工程指示 / 要求簡箋(E.I.)

工程指示編號：EI / 2439 / 20 修改版次：A

工程編號：J - 852 工程名稱：亞皆老街中電

工程項目：後加工程報價 - 百葉 (PODIUM)

GROUND FLOOR PLAN (G/F)

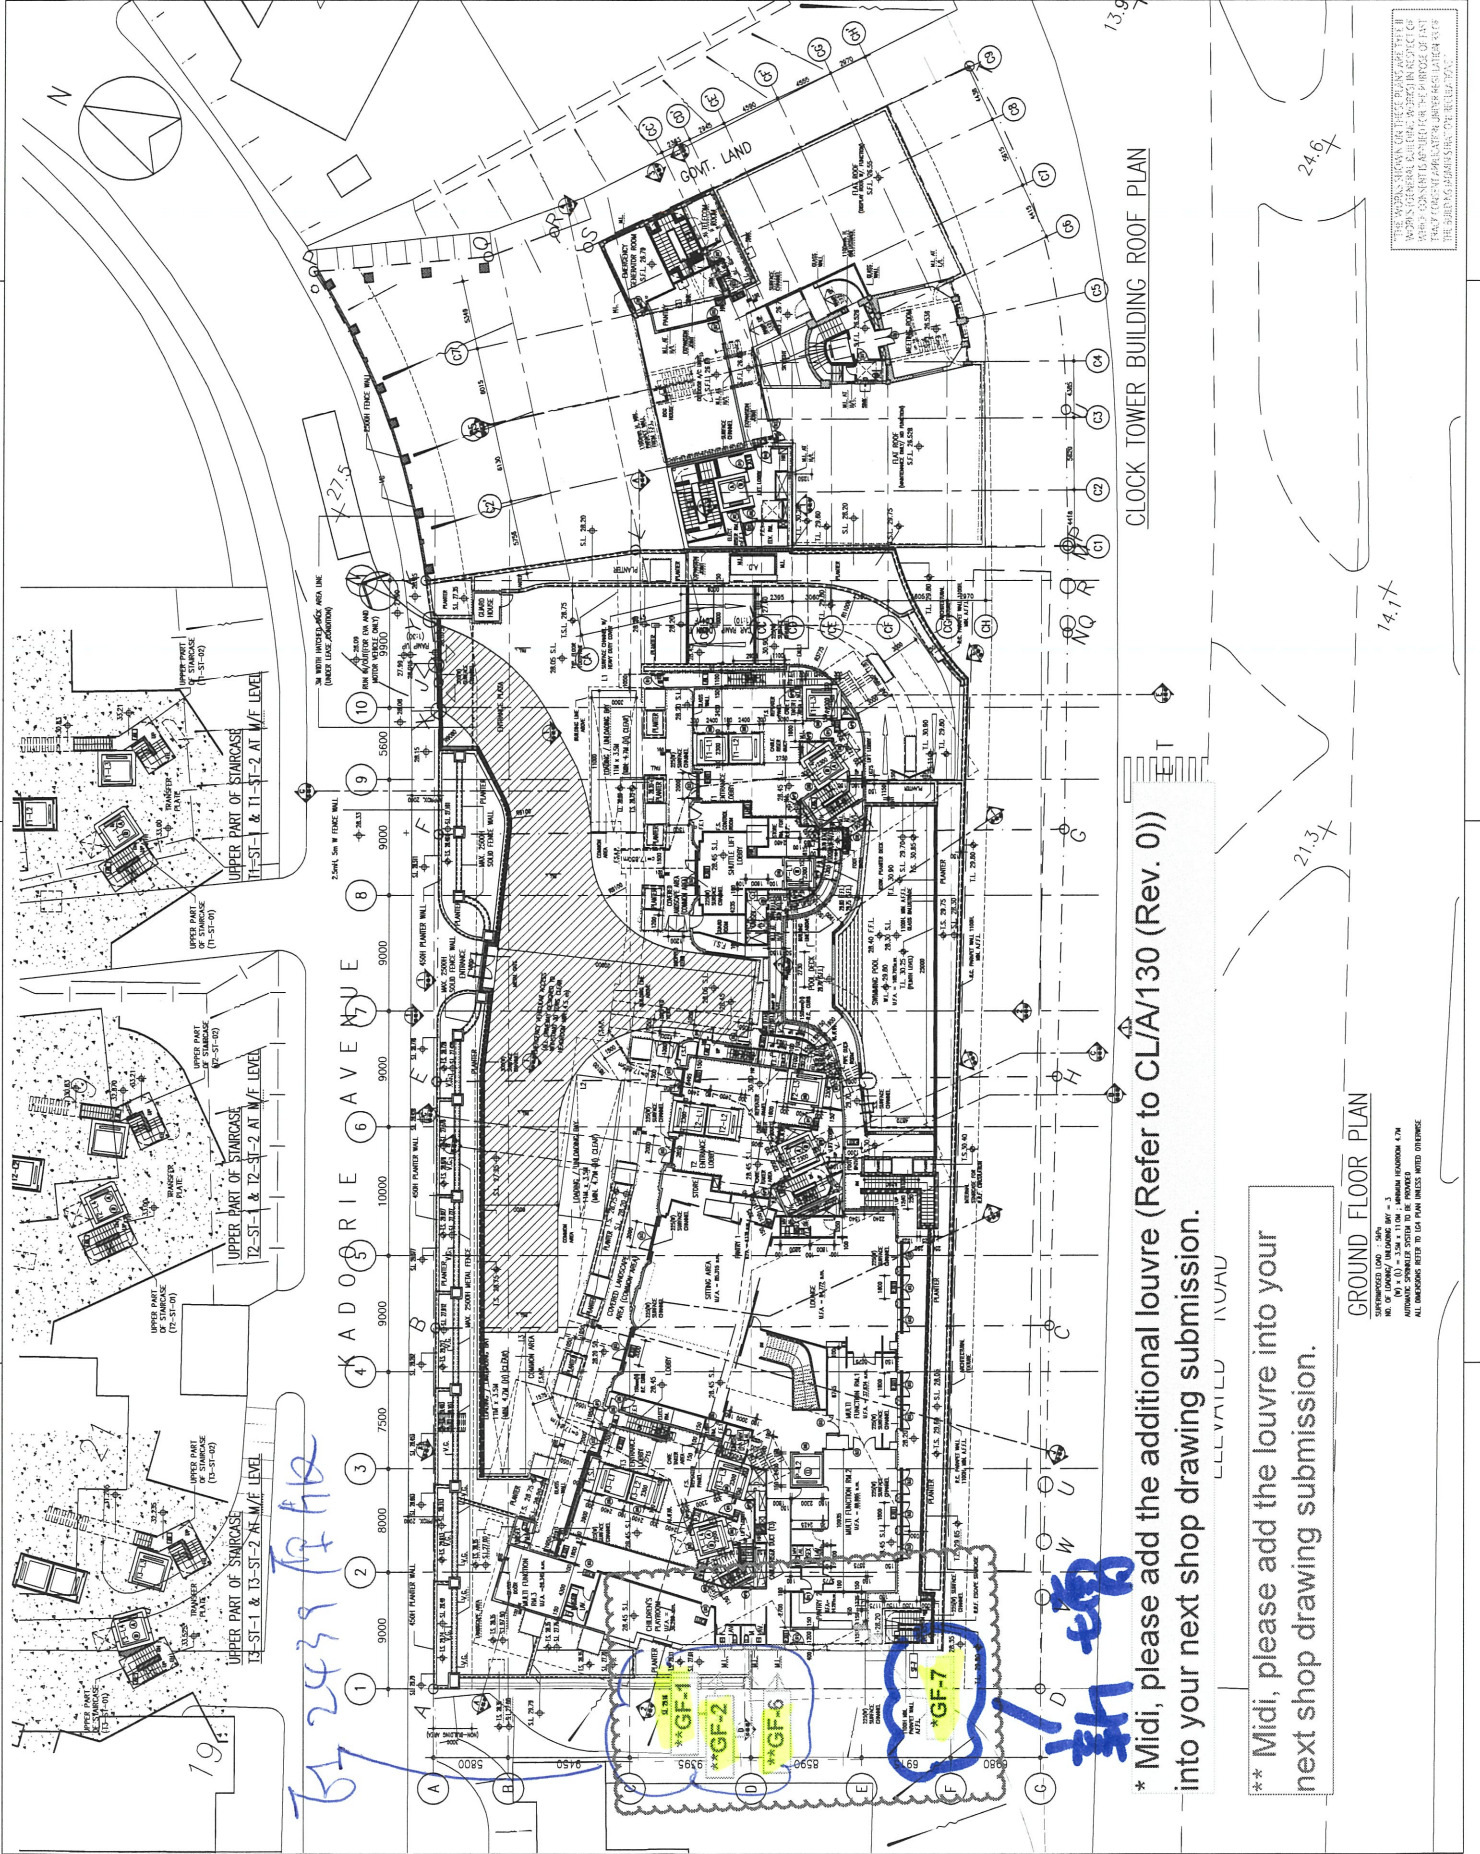
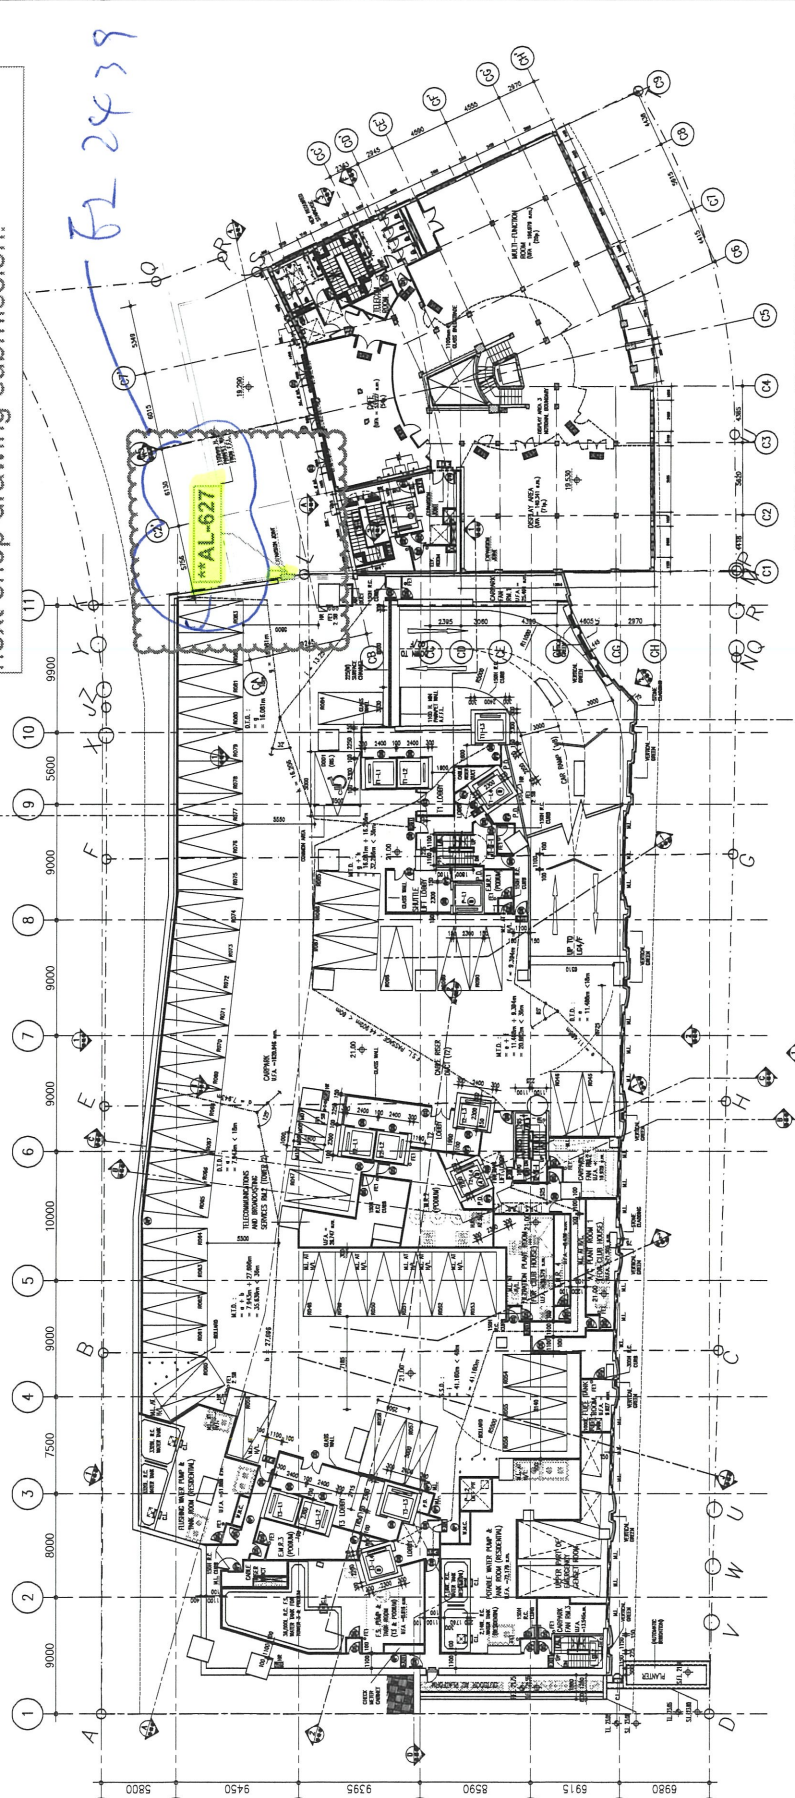
* Midi, please add the additional louvre (Refer to CL/A/130 (Rev. 0)) into your next shop drawing submission.

** Midi, please add the louvre into your next shop drawing submission.

**Midi, please add the louvre into your next shop drawing submission.

Part Plan of Louvre mark-up for G/F at Podium
Arch: 2020.10.27 GBP
Date: 2020.10.30

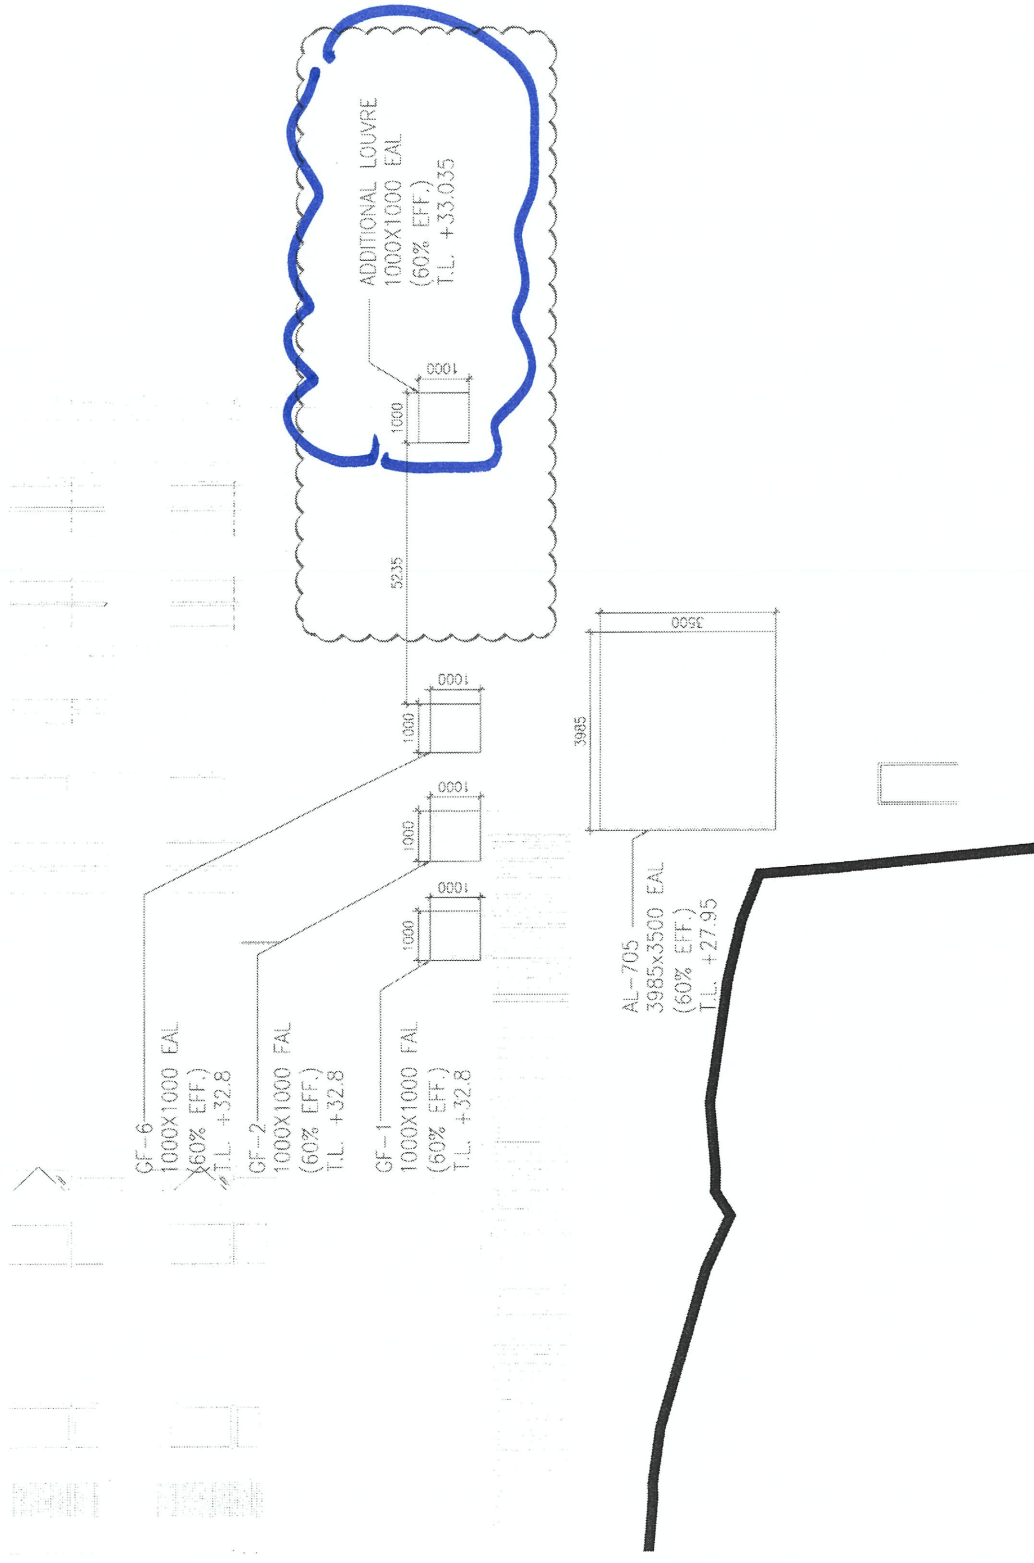
Subject Description: Confirmation of Additional Louvre for G/F

Further to the aforesaid ad hoc meeting, we are confirmed the additional louvre size and level was confirmed by SBSE of Pacific Shine on 30 October 2020. The attached drawing (SK-01) are enclosed herewith for your reference.

Part Plan of Elevation Louvre mark-up for Podium
Arch: 2020.10.27 GBP
Date: 2020.10.30

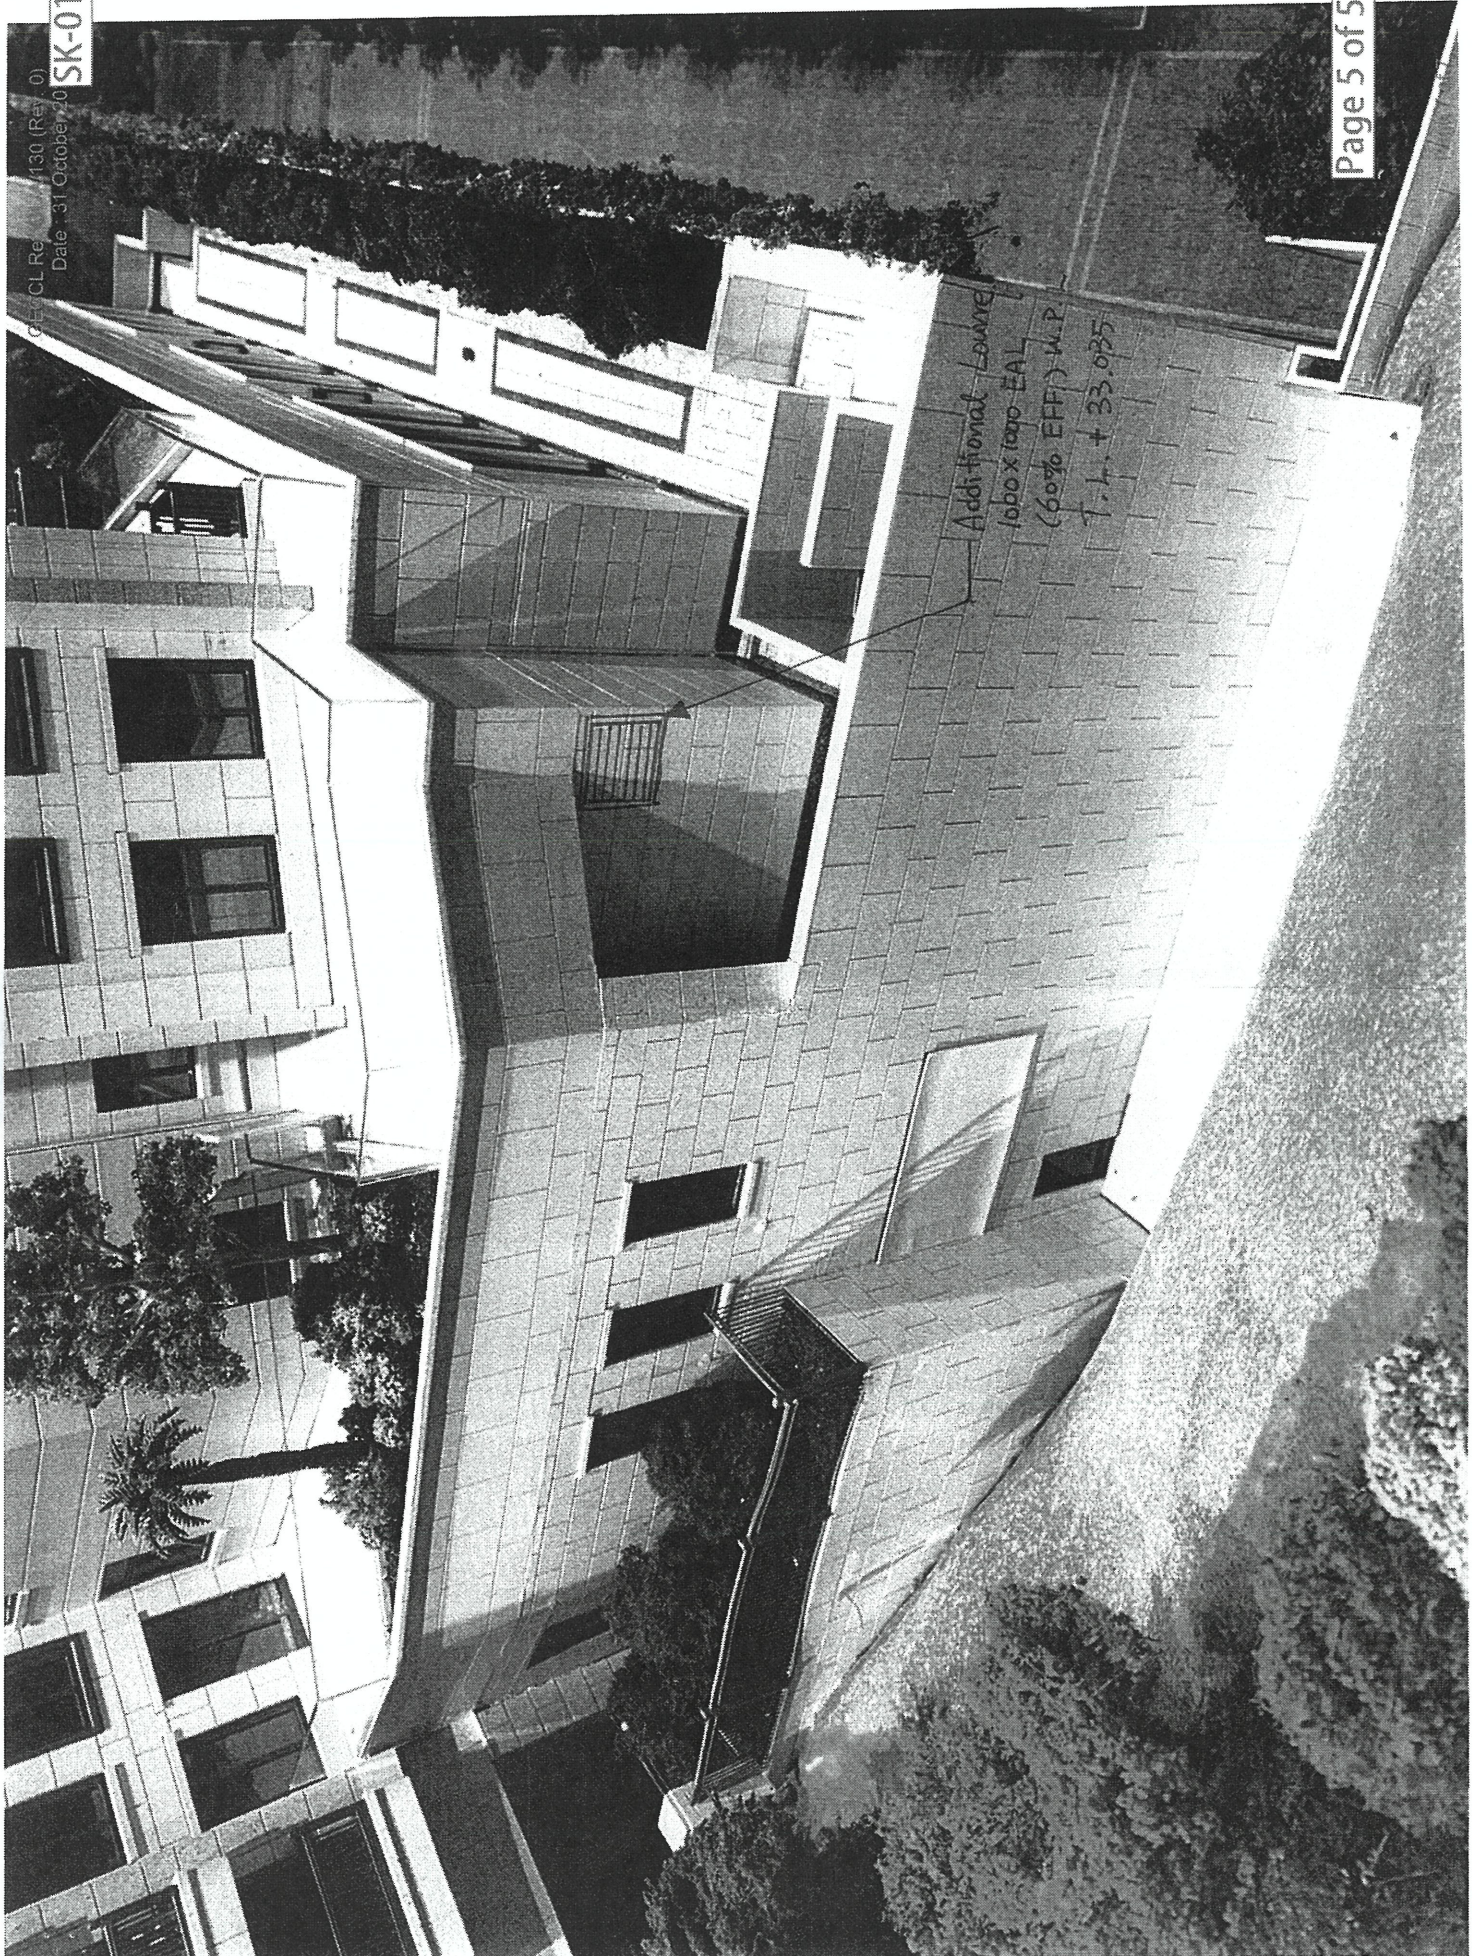
Additional Louvre
1000 x 1000 EAL
(60% EFF) W.P.
T.L. + 33.035
